Report to Planning and Environment Committee

To: Chair and Members
Planning & Environment Committee
From: Scott Mathers, MPA, P. Eng.,
Deputy City Manager, Planning and Economic Development
Subject: 1503 Hyde Park Road
Public Participation Meeting
Date: May 30, 2022

Figure 6. Revised Site Concept Plan (Second Submission)

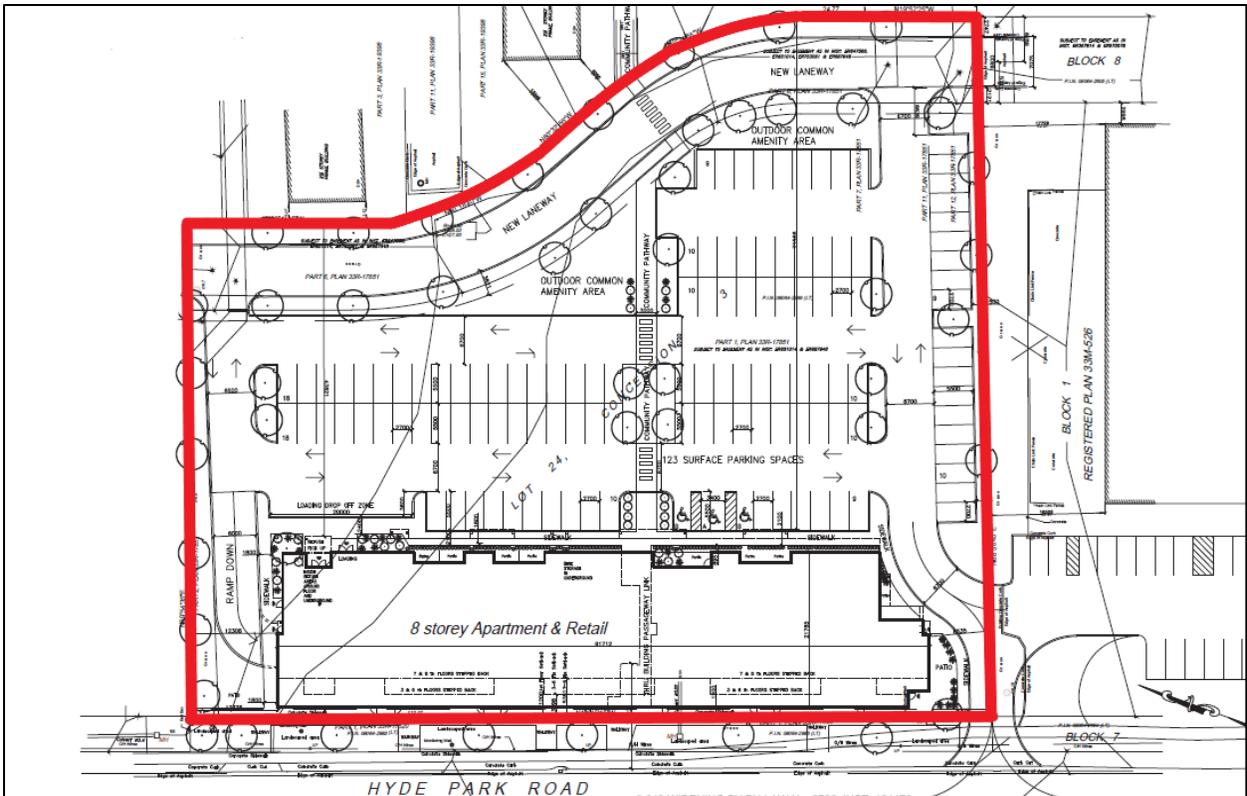
- Break down the massing and length of the upper levels of the building;
- Improve streetscape presence in the design of the lower floors and provide sufficient step-backs from Hyde Park Road;
- Improve the pedestrian circulation from the streets and around the building and provide enhanced landscaping and variation in paving materials to reinforce the pedestrian thoroughfare;
- Reduce the gap in the street wall created by the setback from the underground parking garage access;

- Consider allocating additional space along the Hyde Park facade to outdoor patios and/or amenity areas;
- Provide a landscape/hardscape treatment that is consistent with other recently approved developments in the area.

The Applicant met with Planning and Urban Design staff on two separate occasions to develop and provide for a more appropriate design solution. Revised drawings were submitted to staff on February 18, 2022, and on March 17, 2022 with the following changes:

- The upper building parapets were varied in height to break up the length of the roofline and building volume;
- The use of step-backs at various elevations were provided in order to provide interest and break up the massing of the building. More specifically, the first two floors were setback from the Hyde Park Road right-of-way with a 1.0m minimum and a 2.0 metre maximum setback, the third to sixth floors had a step-back of 2.0 metres plus the setback established for the first and second floors, and the seventh and eighth floors had a step-back of 4.0 metres plus the setback established for the first and second floors;

- An alternative colour was added to the centre of building to break up the overall building volume, while also creating a focal point for the apartment entrance and pedestrian link.

Figure 8. Step-Back and Setbacks from the Hyde Park ROW for the Proposed Development, Section Drawing (Third Submission)

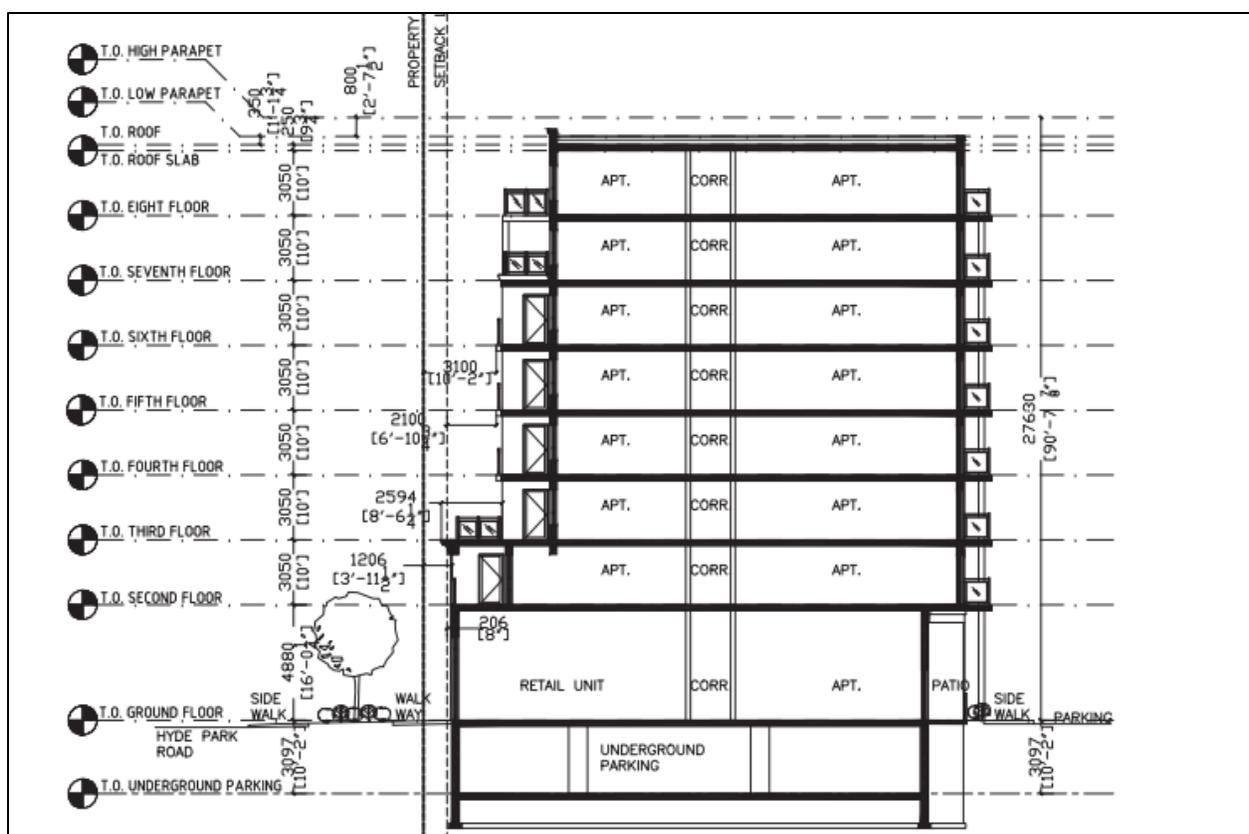
- Consider breaking up the apparent length of the building by incorporating vertical articulation elements that extends up from the ground.
- Provide an adequate setback of minimum 3m above the 4th or 5th Storey along the street frontage in order to provide for a more human-scale environment along the street.

Planning and Urban Design staff are satisfied that their concerns have been appropriately addressed through the above-noted changes and the proposed step-backs are to be “locked-in” as part of this amendment through the use of special provisions. Overall, City staff are of the opinion that the proposed mixed-residential development is appropriate and sensitive to the abutting lands and provides a form of compatibility that aligns with the design, density, height, and scale of the adjacent land uses and surrounding neighbourhood. The Applicant is commended for incorporating a built form that establishes a built edge along Hyde Park Road; active ground floor commercial/retail units with individual entrances facing the street; a pedestrian connection through the building that connects the walkway between Coronation Drive and Hyde Park Road; an appropriate transition to single family homes towards the east; and locating the majority of parking underground and internal to the site away from the public street frontage. City staff will continue to work with the Applicant at the Site Plan stage to incorporate appropriate building and site design features in the final approved drawings and development agreement.
